Docket No. LC 76

CASCADE NATURAL GAS COMPANY,

2020 Integrated Resource Plan Update

STAFF COMMENTS

Figure 2: Staff’s Current Approach for Analyzing Distribution System Upgrades

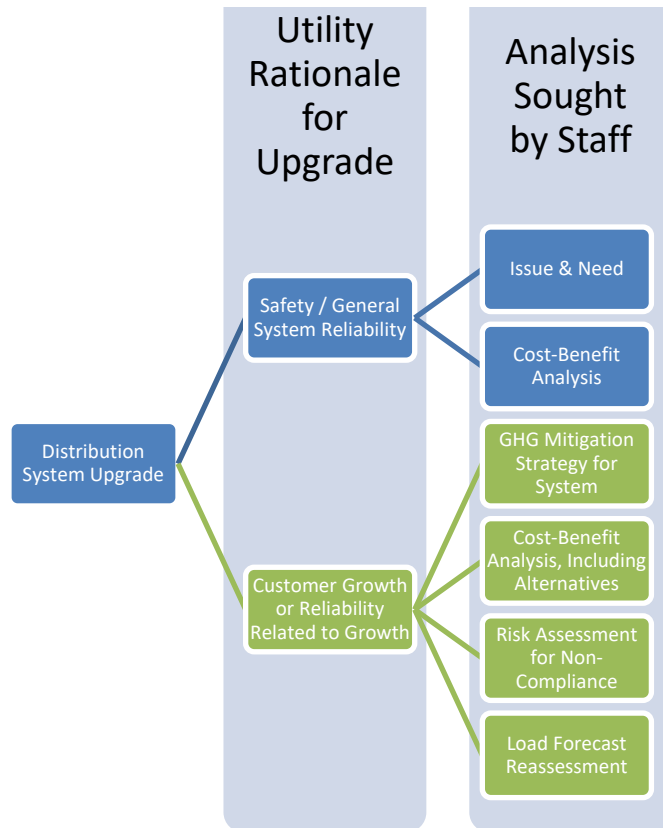
In sharing the above, Staff would also note that this is an evolving rubric for approaching proposed gas distribution system upgrades. Staff notes that this rubric is subject to change, including future Commission direction and Orders that may direct Staff’s analysis on this analysis.

In short, it is currently difficult for Staff to apply the new rubric for assessing distribution system upgrades explained in Figure 2. With the current information the Company has provided, Staff cannot parse necessary safety and reliability upgrades from those due to forecasted growth for most of the proposed projects. When Staff asked Cascade to detail the specific safety and reliability concerns from not completing each proposed upgrade, Cascade shared a blanket statement that not completing the projects would jeopardize the ability to meet peak day

Figure 3: Cascade's Forecasted CPP Compliance

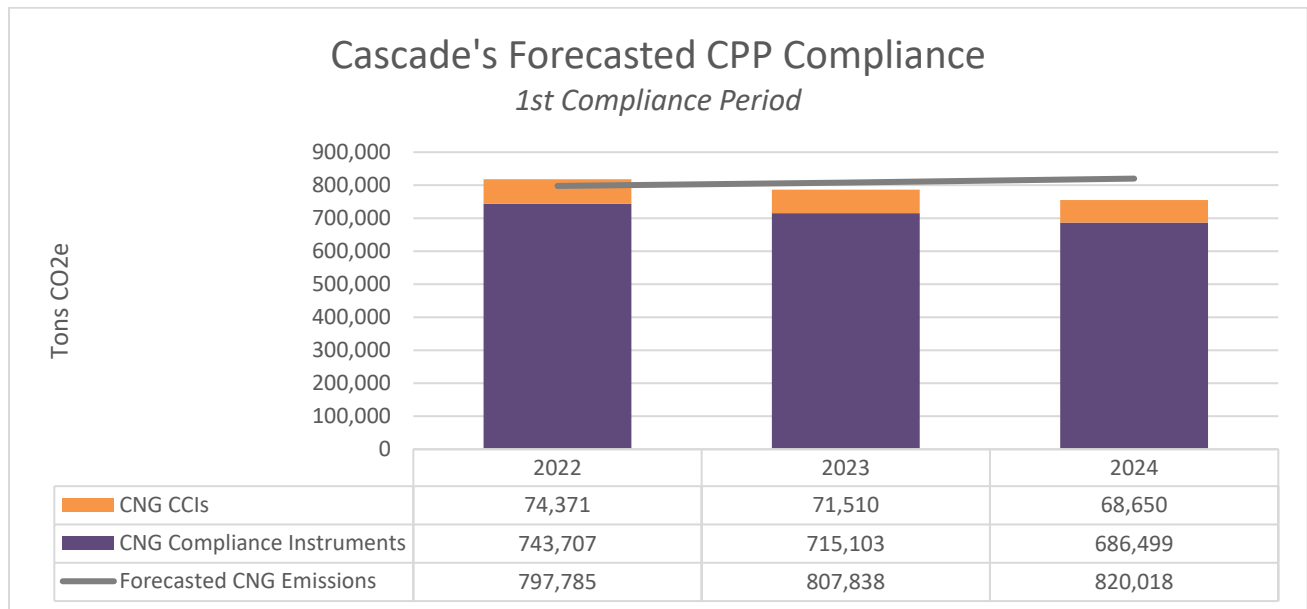
Using publicly-available data and information provided through the IRP Update, Staff estimates that for the first CPP compliance period (2022 to 2024) the Company’s covered emissions will exceed CPP compliance instruments. Specifically, by the end of 2024 and assuming no major changes in activities, Cascade appears on a path to experience a net deficit of approximately 66,000 tons, illustrated in Figure 3.

It appears to Staff that the resource decisions proposed in the current IRP Update compromise the Company’s ability to comply with the CPP in 2022 and do not show alignment with or responsiveness to the strategies the Company proposed in UM 2178 to which the Company points. Further, no additional plans were articulated in the IRP Update for enhanced resource acquisitions in 2023. Staff also understands that Cascade’s 2024 compliance activities are still in development via the IRP process. However, those activities will need to compensate for any net

8. In reply comments, confirm the accuracy of Staff's analysis of Cascade's 2022-2024 CPP compliance net deficit and potential financial risks with supporting data.

Figure 4: Cascade Forecasted Sales Relative to Bend’s 2030 Fossil Fuel Reduction Goal

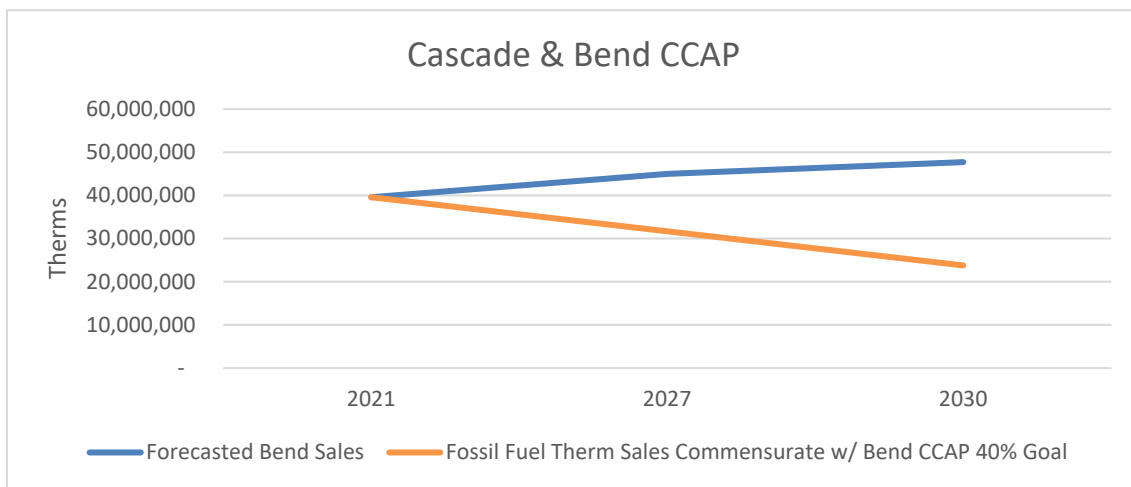
The Bend CCAP does not assign a specific amount of fossil fuel reduction to Cascade to meet the community’s 2030 goals. However, Cascade’s 2021 emissions represent approximately 26 percent of the Bend baseline total community GHG emissions. For Cascade to achieve a commensurate 40 percent reduction in fossil fuel use *in Bend*, using 2021 as a baseline, Staff estimates CNG would need to avoid approximately 83,900 MT CO2e emissions by removing or replacing approximately 15.8 million therms of fossil fuels, demonstrated in Figure 4.

- 17. In reply comments, confirm Staff’s analysis of a reduction in fossil fuel, natural gas sales commensurate to meet the 40 percent reduction goal of the Bend CCAP.
- 18. In reply comments, discuss how Cascade will update Bend’s Environment and Climate Committee, who oversees CCAP implementation, on its growth in Bend, associated emissions, and plans to mitigate those emissions.
